DOCKET 50-312
RANCHO SECO NUCLEAR GENERATING
STATION UNIT NO 1
HIGH PRESSURE INJECTION NOZZLE
CYCLES

FIELD CHANGE AUTHORIZATION

FC-0174-00

CUSTOMER SMUD	ORIGINATOR K.C. Smith	DATE 6-11-80	CONT. NO. 620-0011	DOC. I.D. NO. 04-3370-00	REV. NO.
SUPPLIER Babcock & Wilcox	P.A. NO.		PART NO., OR. TASK NO.	GROUP NO.	SEQ. NO.
TITLE (MAX 30 CHARACTERS) HPI Nozzle			50	001	001

FIGURE 8-14

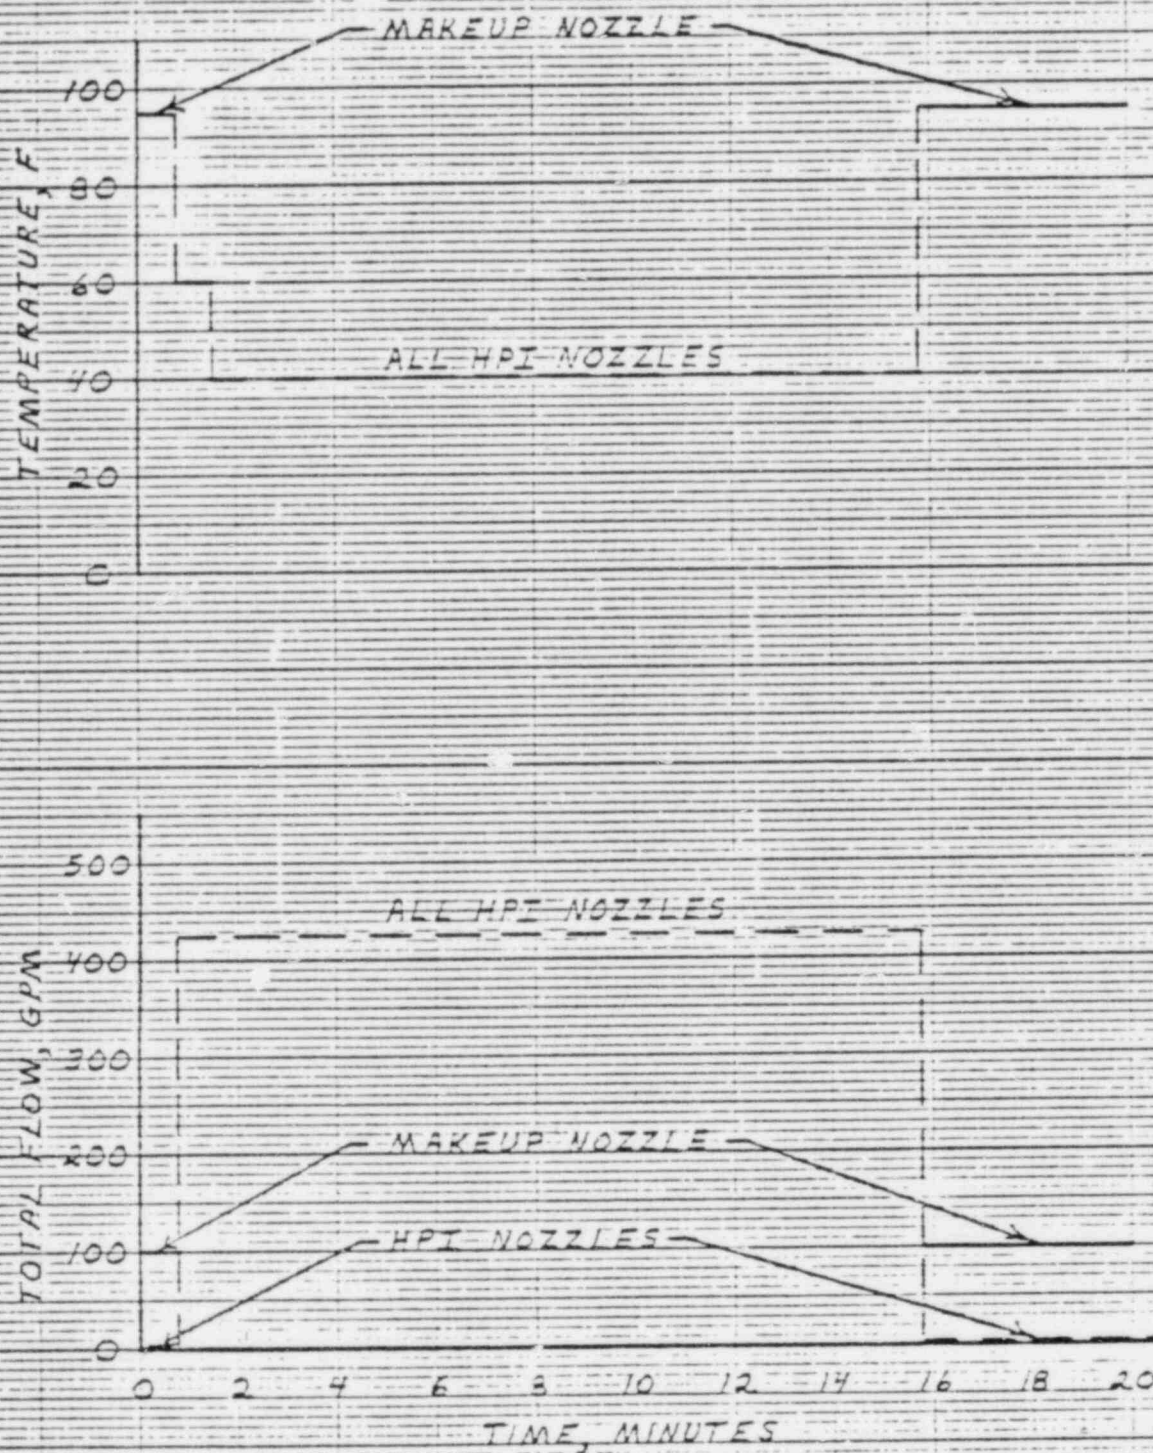
1. A revision to Section 6.9, Transient 8- Reactor Trip. Specifically, paragraphs will be added to sections 6.9.2 and 6.9.3.1 of the text to provide for manual actuation of the high pressure injection system after a reactor trip.
2. Table 2 will be revised to include 70 design cycles for the above noted change.
3. Figure 8-14 will be added to the spec.

Manual Actuation of High Pressure Injection System After Reactor Trip - Figure 8-14

Occasionally after a reactor trip, it may be necessary to manually actuate the high pressure injection system in order to obtain additional makeup flow. This should only be done to prevent the loss of indicated pressurizer level during the transient. For the total of 400 reactor trip events, an allowance of 70 cycles of high pressure injection system actuations shall be considered for design purposes.
